This application is inappropriate in scale, scope, and setting. Its approval would cause permanent damage to Weybread's ecology, heritage, and quality of life.

Annex A: Walked Tree Survey of Weybread – With Recent Photographs

A row of 10 apple trees along the bund wall seen from FP14 (not 2 apple saplings as stated on the planning application)

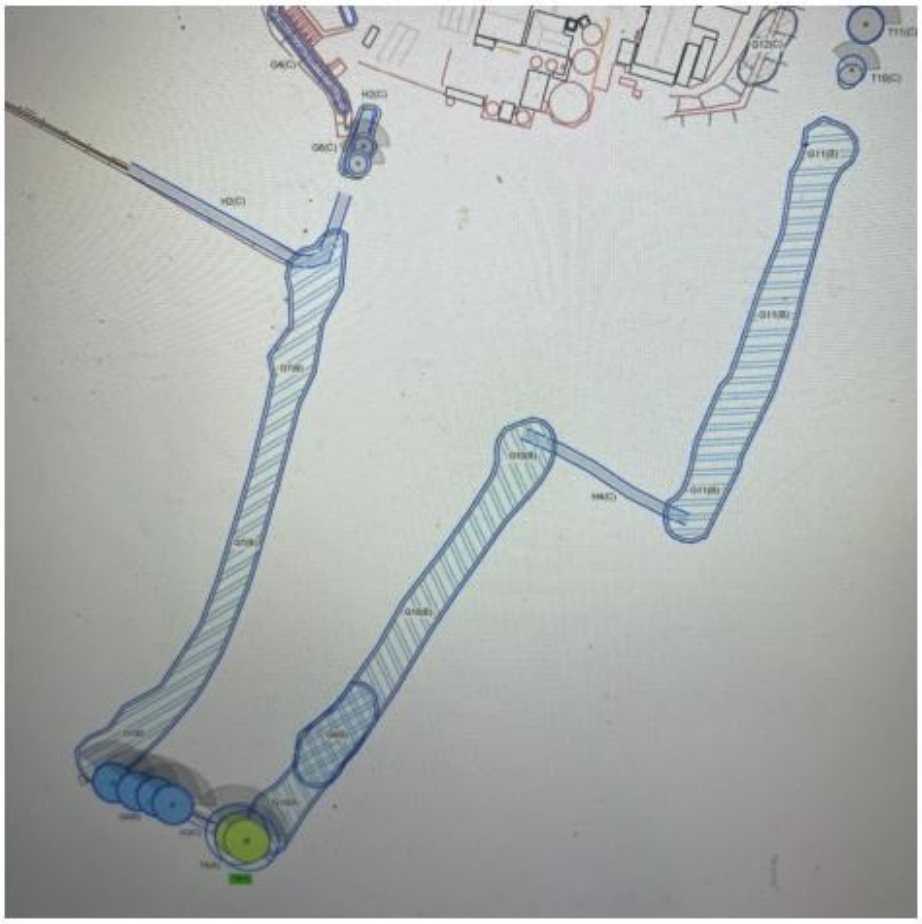
- **Apple Trees (x10)** – Mature fruit trees along bund
  - *Condition*: Healthy, mature, fruit-bearing
  - *Recommendation*: Retain and TPO; misidentified in application as saplings
- **G4**, **G5**, **H2** – Ash and mixed hedge groups along bund edge
  - *Recommendation*: Retain with TPO to preserve corridor connectivity
- **Hedges around Western Field** – Ancient double hedgerow and ditch system
  - *Recommendation*: Retain all boundaries including the bund wall; key to habitat connectivity
